Subject: CONSOLE MAT WARPING CAUSING POOR APPEARANCE	Bulletin No: 09-019/16
	Last Issued: 03/24/2016

2016 MX-5 vehicles with VINs lower than JM1ND*****103512 (produced before July 9, 2015)

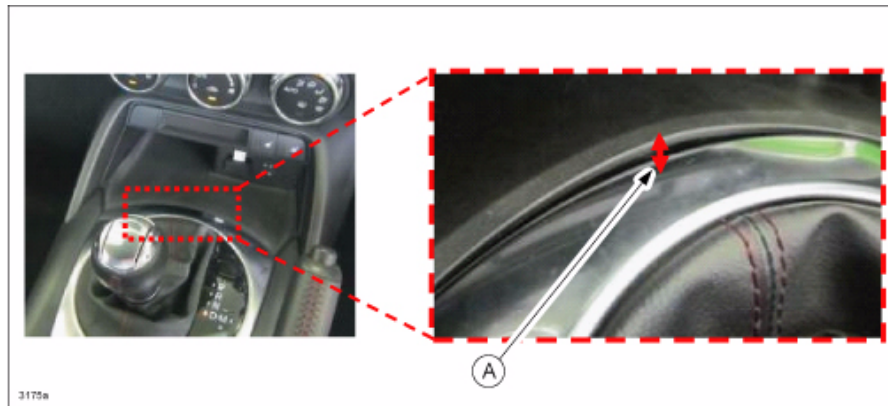
Some vehicles operating in places with high ambient temperatures may exhibit the console mat warping at the center part (A), causing a poor appearance. The console mat is fixed at both ends and warpage of the center part is caused by heat influence.

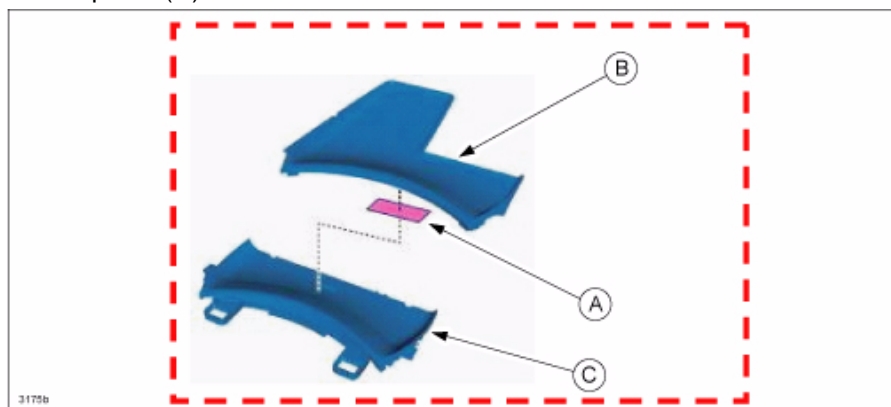
To prevent the console mat from warping, double-sided adhesive tape (A) has been added between the console mat (B) and the console panel (C).

1. Verify customer concern.
2. Replace the front console box assembly with a modified one according to the instructions on MS3 online or the Workshop Manual (section 09-17 CONSOLE PANEL REMOVAL/INSTALLATION).
3. Verify repair.
